Technical Bulletin

## Tension setting procedure for PSA 2.2 HDI engines

<b>GATES REFERENCE :</b>	<b>5558XS/K015558XS/K025558XS/KP15558XS/ KP25558XS</b>	
<b>MAKE :</b>	<b>CITROEN, FIAT, LANCIA, PEUGEOT</b>	
<b>MODEL :</b>	<b>C5, C8, Ulysse, Phedra, 406, 607, 807</b>	
<b>ENGINE :</b>	<b>2.2 D</b>	
<b>ENGINE CODE :</b>	<b>DW12TED4, 4H01, 4HW</b>

Fig. 2

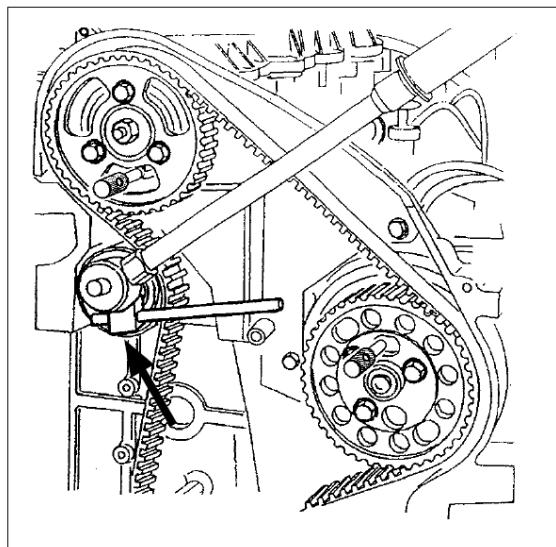
- This tool is needed in order to turn the tensioner and hold it in place while tightening the locking bolt (25 Nm) (Fig. 2).

Fig. 3

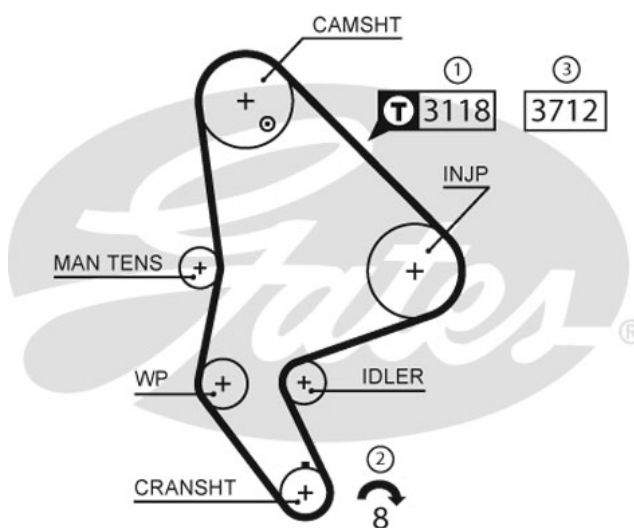
- ① - Initially, the belt has to be installed at a higher than normal tension (pretension).  
The tension is measured with a Gates STT-1 tension tester in the span between the camshaft and the injection pump. Enter code 3118.
- ② - The crankshaft pulley is then rotated 8 revolutions, clockwise
- ③ - The tension is then adjusted to the final level, and the value is again confirmed with the STT-1 tension tester. Enter code 3712.

The procedure will be visualised on the PowerGrip<sup>®</sup> Kit and belt box label as in Fig 3.

Fig 4

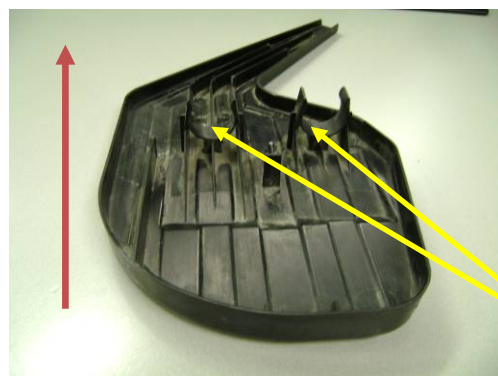
On C8 and 807, PSA recommends sliding a special water drainage cover (OE nbr 824871) under the expansion tank, so water (coming from the windscreen) can no longer infiltrate into the timing system (Fig 4). The change interval has been reduced to 120.000 KM (70.000 miles) or 5 years (3 years under adverse conditions).

Goes over hard part of expansion tank hoses.
